MARK	REVISIONS	BY	APPR.	DATE
▲	REVISED WILDLIFE FENCE MESH	NCM	ADDEN#3	04/16/2024

**CONSTRUCTION DETAILS**  
**HSIP-GILMAN SPRINGS RD**  
FROM 8,920' S/O ALESSANDRO  
BLVD TO 5,340' S/O BRIDGE ST

ISSUED BY ADDENDUM No. 3, ATTACHMENT "A"

**WILDLIFE FENCE - FENCE ON SHARP BREAK IN GRADE**

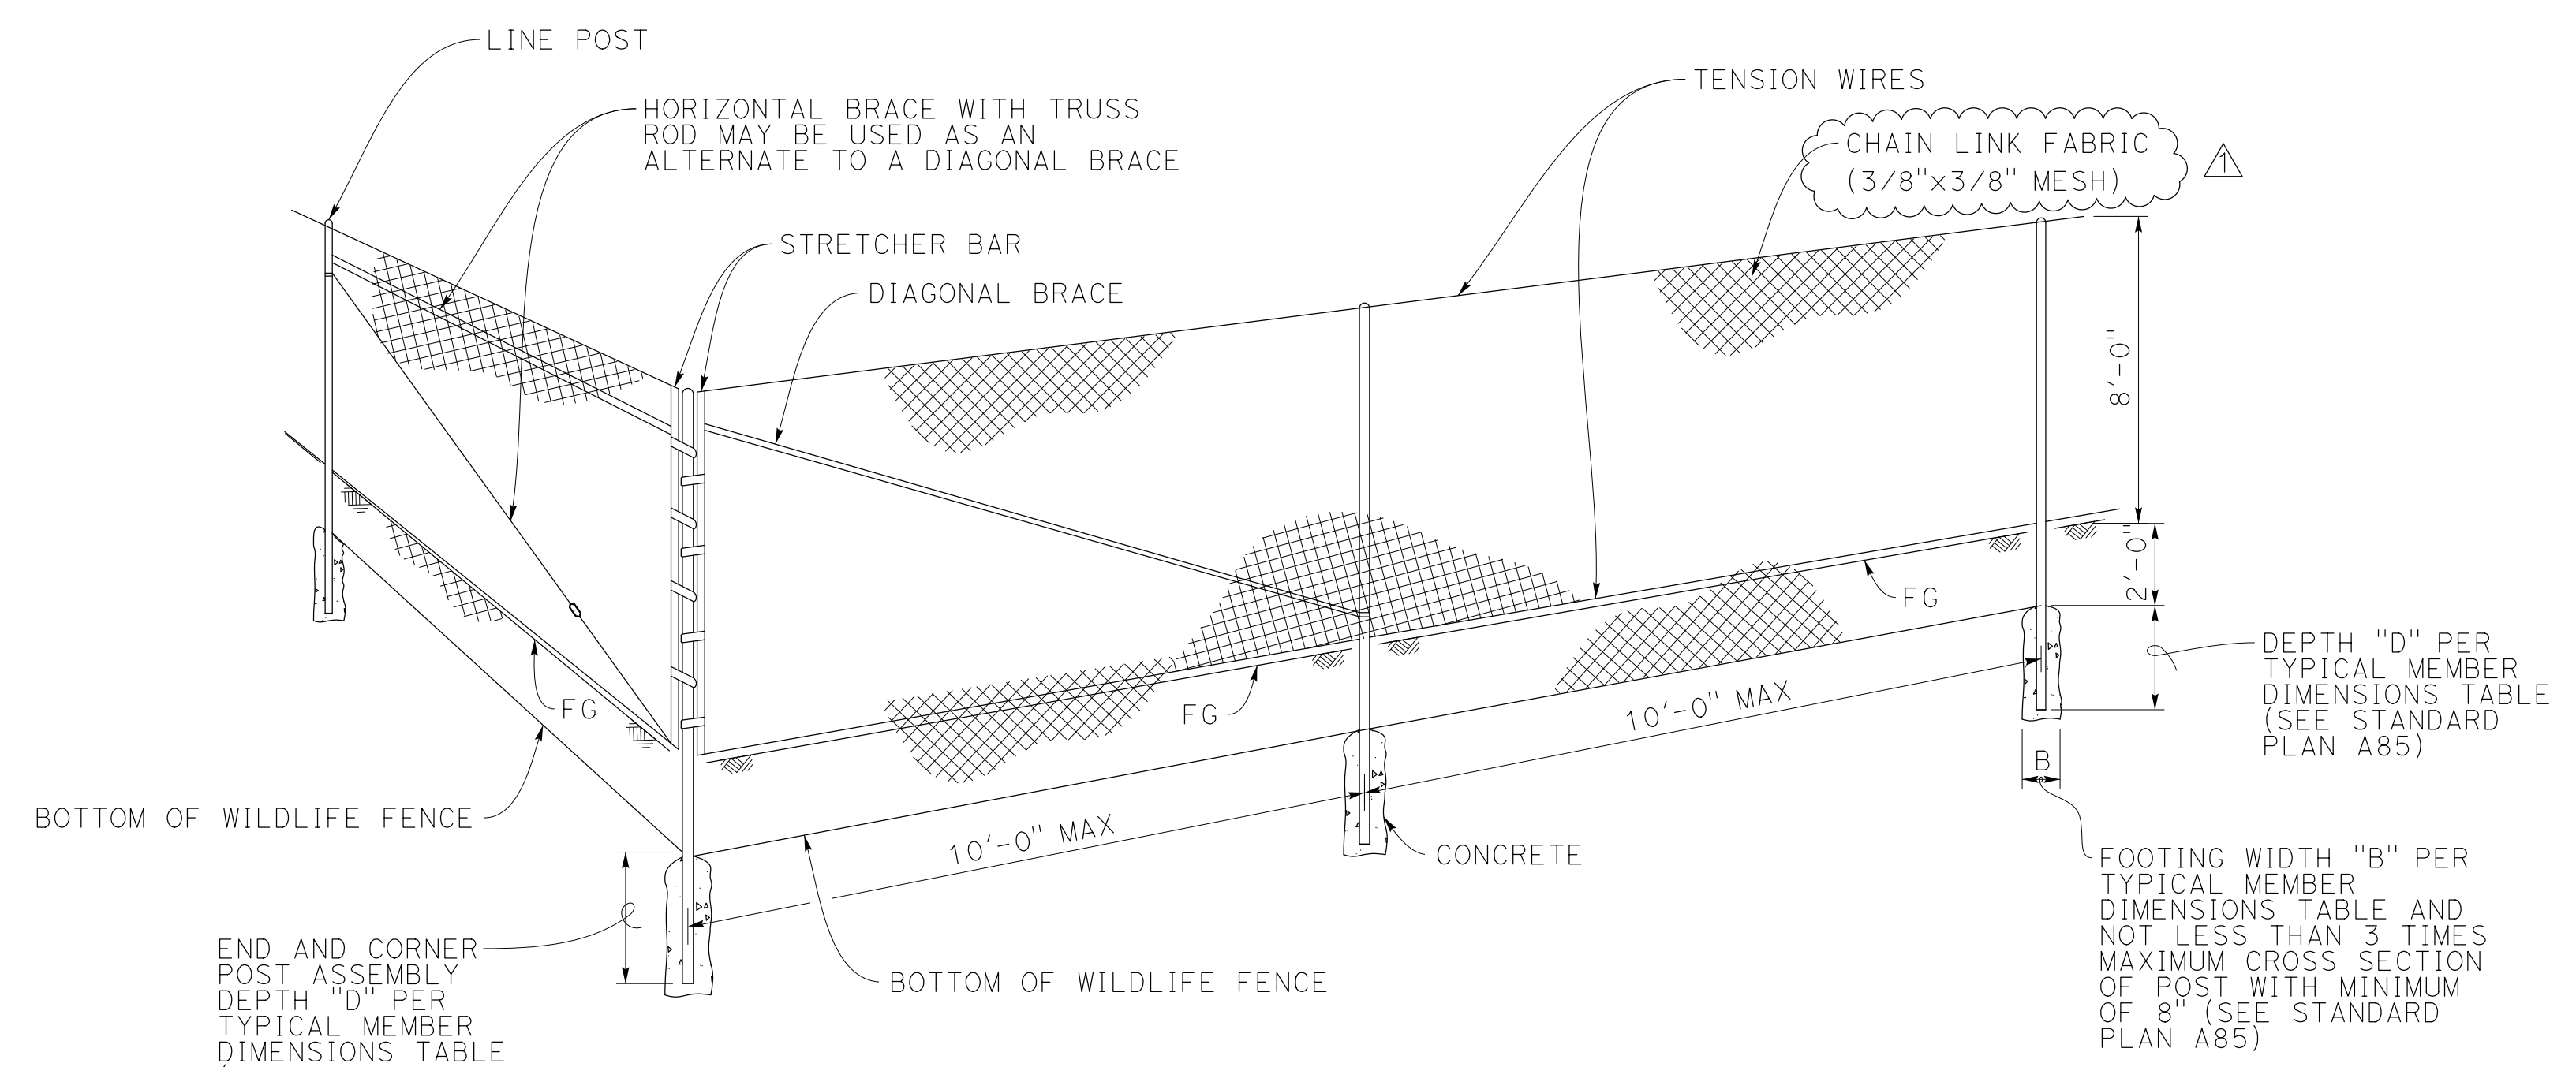
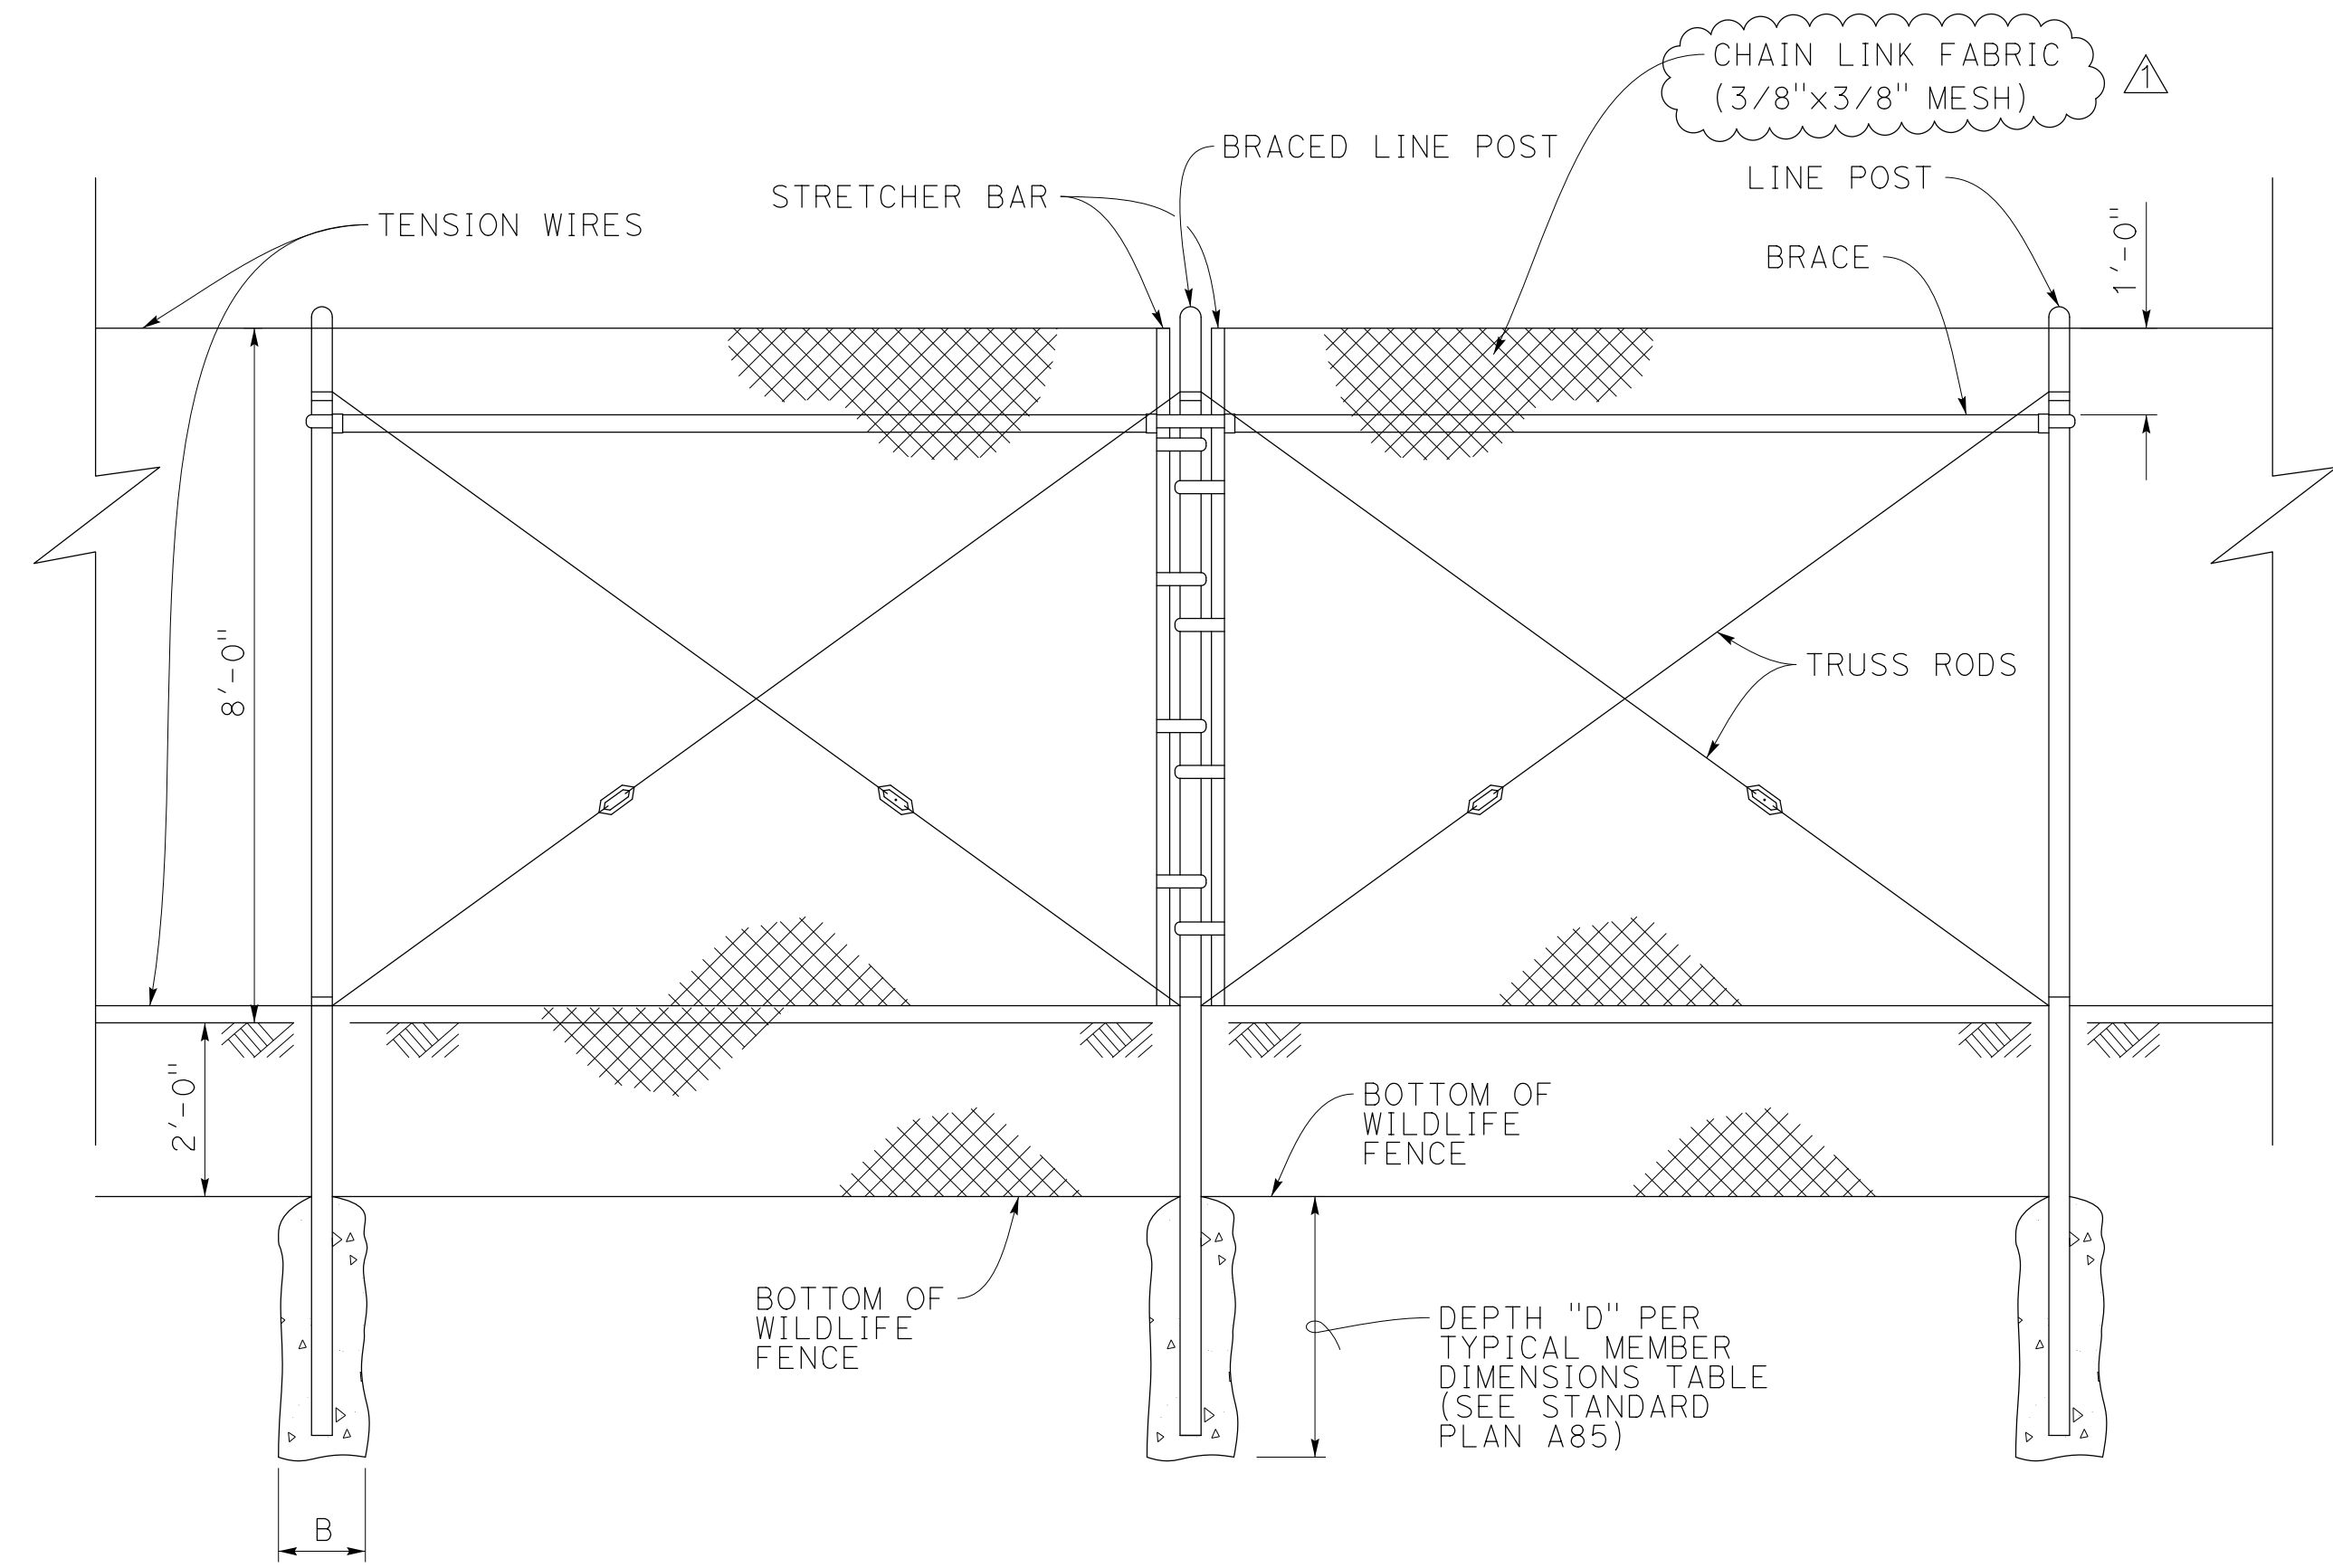
MARK	REVISIONS	BY	APPR.	DATE
△	REVISED WILDLIFE FENCE MESH	NCM	ADDEN#3	04/16/2024

**WILDLIFE FENCE AT CULVERT HEADWALLS**

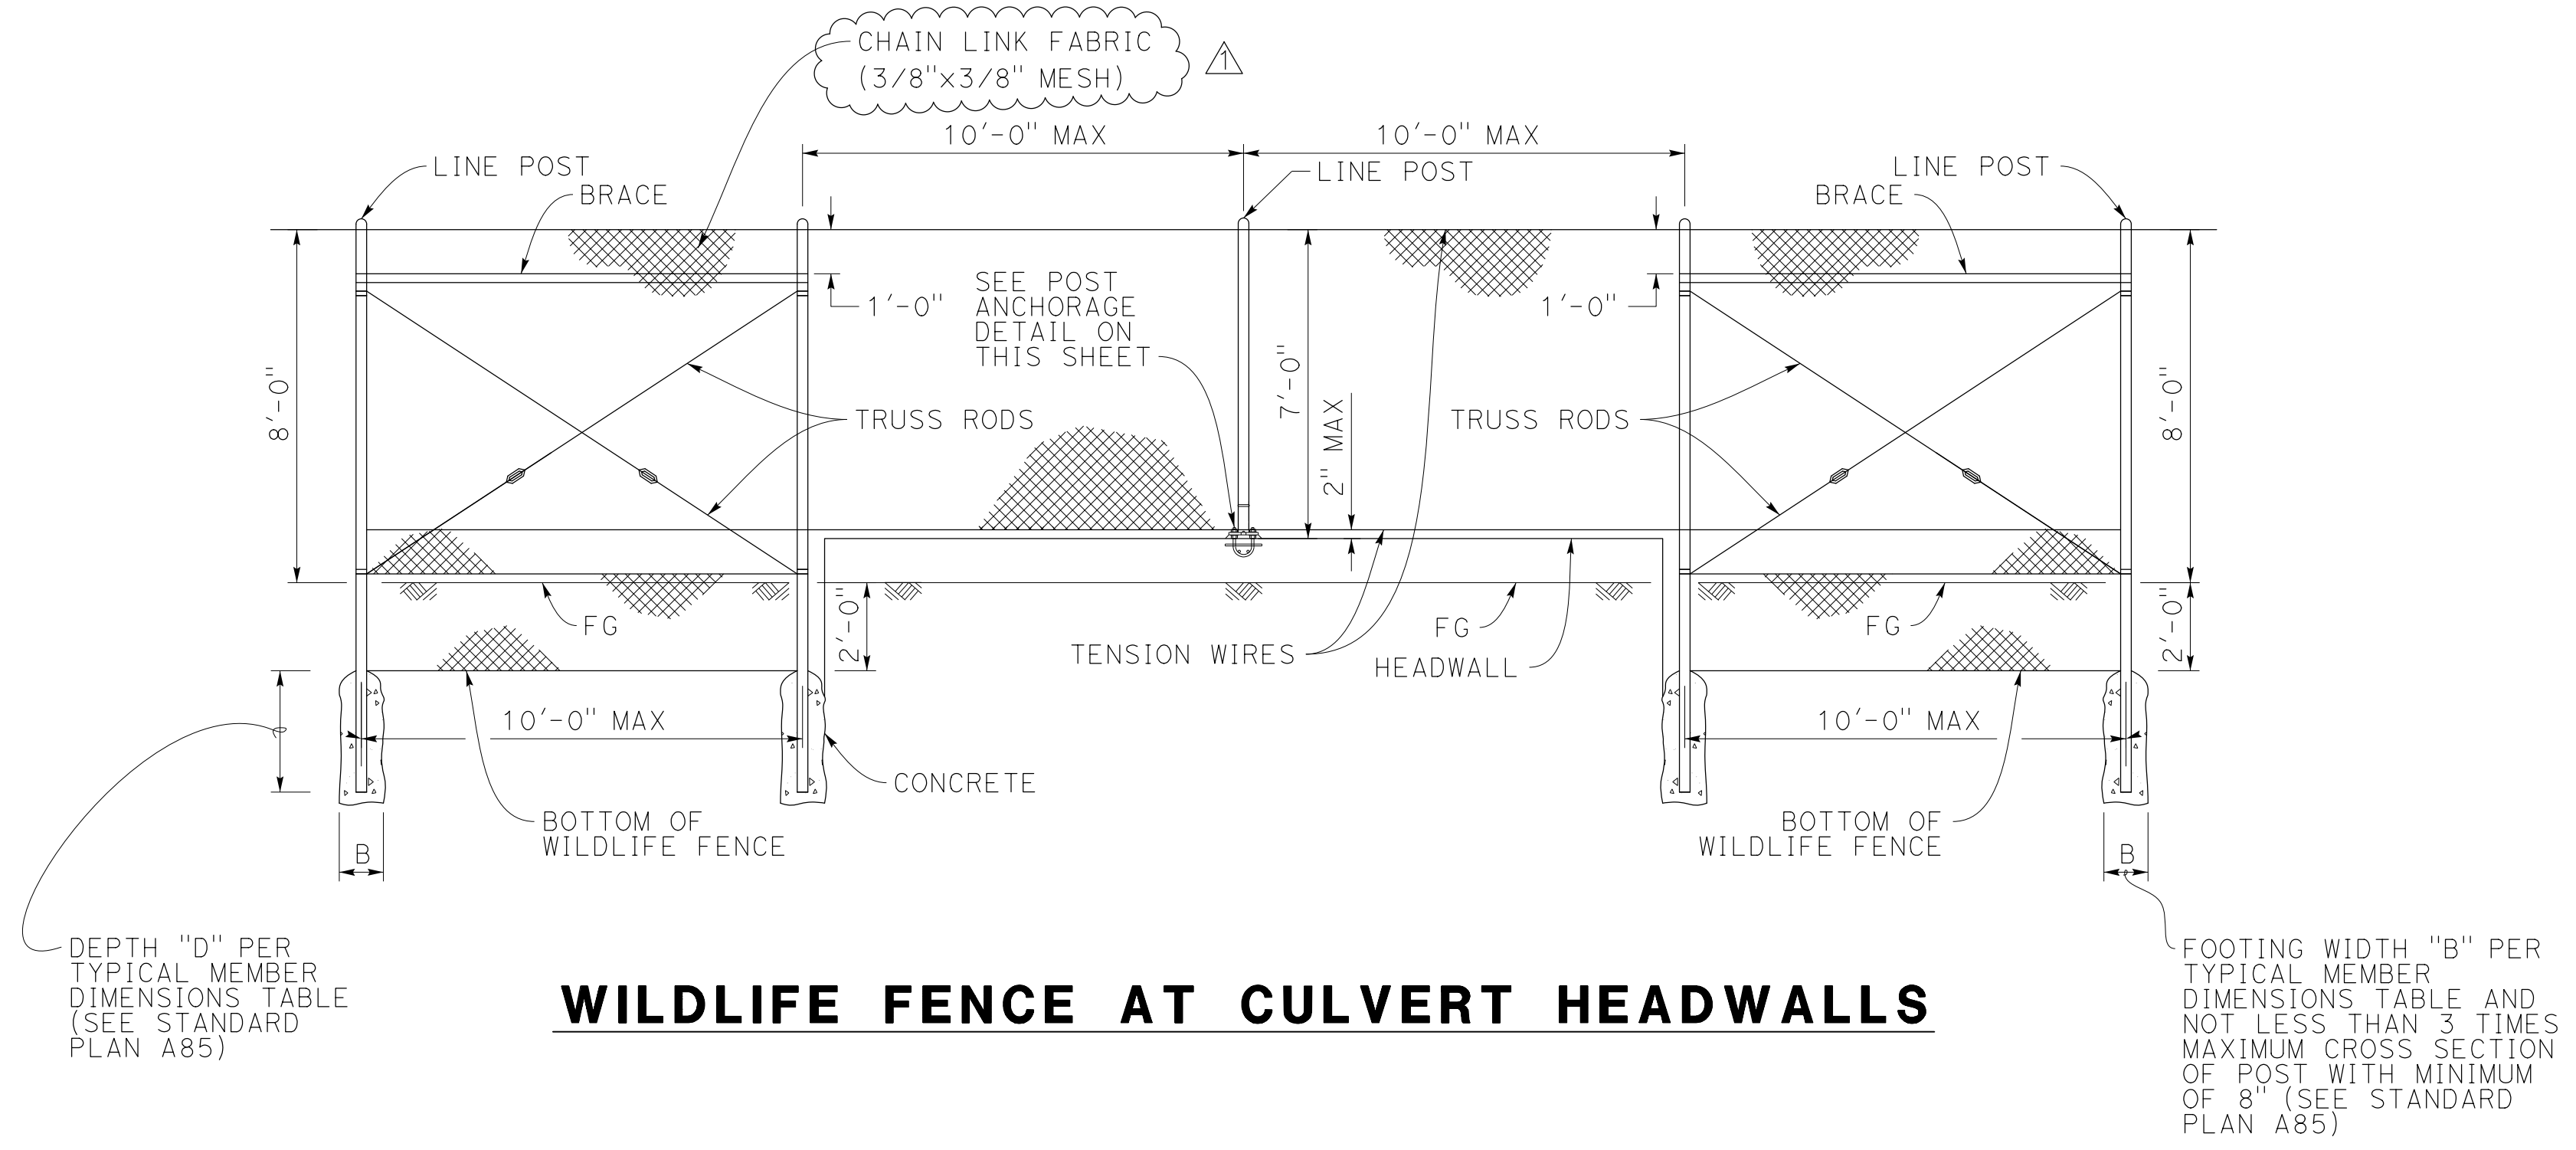
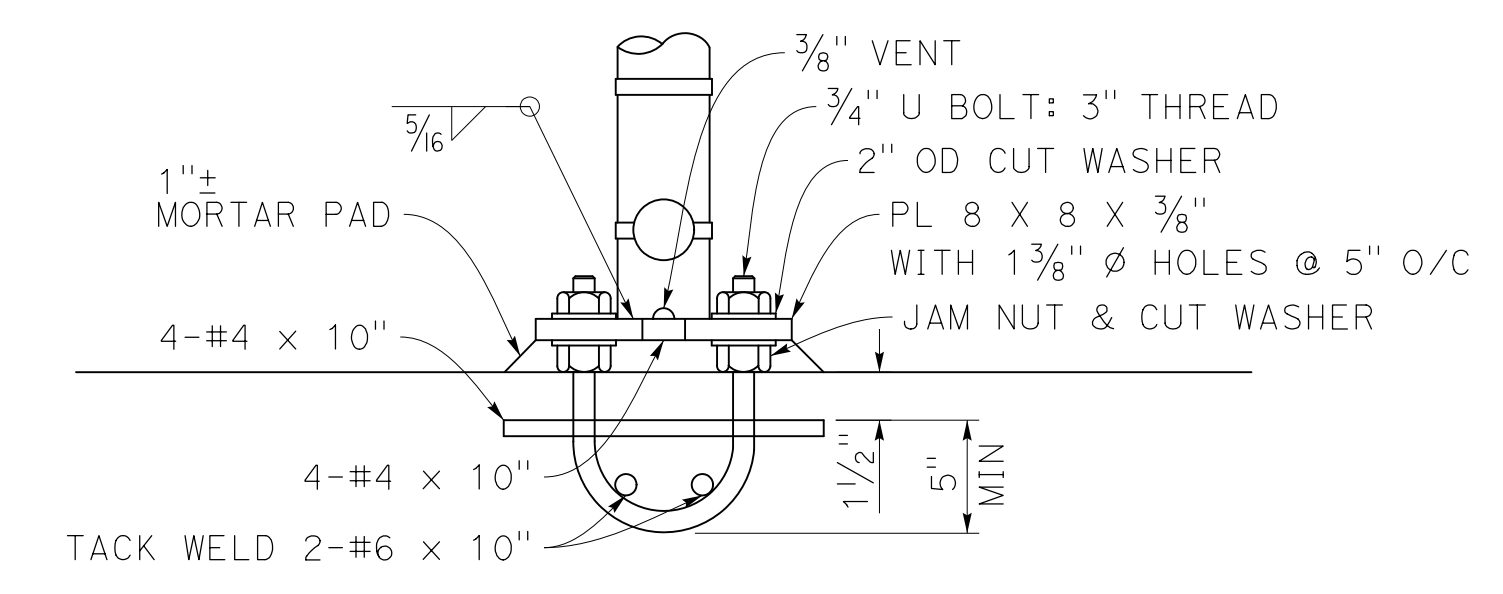
MARK	REVISIONS	BY	APPR.	DATE
△	REVISED WILDLIFE FENCE MESH	NCM	ADDEN#3	04/16/2024
